Access Compliance Report

Public Rights-of-Way

Intersection ID: 52441	Main Street: WOODWARD_AV	Cross Street: BENDING_BIRCH_PL	Location: NE
ADA ID: 2CEAAD191812	Ramp Type: Directional1	Initial Pass/Fail: Fail	Overall Compliance: No
		Severity Score: 12.5

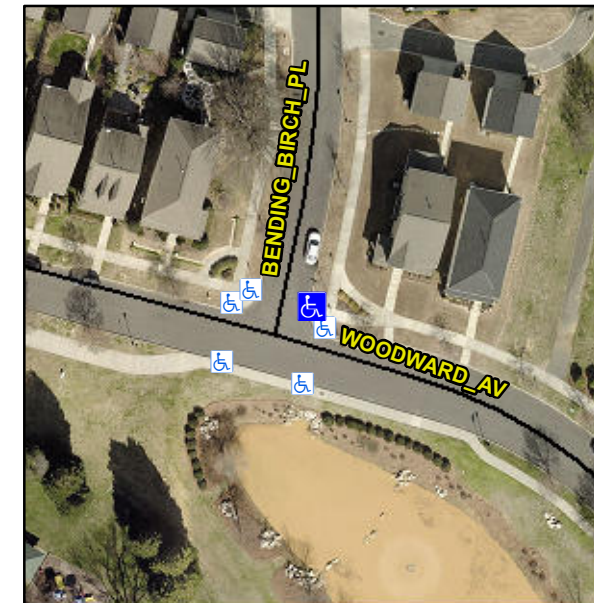
R304.2.2

Compliance	Description	Data	Compliance	Description	Data
N/A	Ramp Length (in)	75.0	N/A	Grade Break?	N/A
Yes	Ramp Width (in)	63.5	N/A	Grade Break Slope (%)	0.0
No	Ramp Slope (%)	9.9	N/A	Grade Break XSlope (%)	0.0
Yes	Ramp XSlope (%)	0.8			
N/A	Flare Type LT	N/A	N/A	Flare Type RT	N/A
N/A	Flare Slope LT (%)	N/A	N/A	Flare Slope RT (%)	0.0
N/A	Flare Traversable LT?	N/A	N/A	Flare Traversable RT?	N/A
N/A	Landing Length (in)	0.0	N/A	DWS Provided?	N/A
N/A	Landing Width (in)	0.0	N/A	DWS Contrast?	N/A
N/A	Landing Slope (%)	0.0	N/A	DWS Length (in)	N/A
N/A	Landing X Slope (%)	0.0	N/A	DWS Full Width?	N/A
N/A	Landing Curb? (Y/N)	N/A	N/A	DWS Offset LT (in)	N/A
N/A	Shared Landing?	N/A	N/A	DWS Offset RT (in)	N/A
N/A	Gutter Ponding?	0.0	N/A	Gutter Slope (%)	N/A
N/A	Gutter Lip Ht (in)	0.0	N/A	Gutter X Slope (%)	N/A
N/A	Painted X Walk1?	No		Road Slope (%)	0.6
	X Walk 1 Direction	To W		Road X Slope (%)	1.8
	X Walk 1 Width (in)	N/A		Clear Space?	N/A

Remove & Replace Entire Ramp.
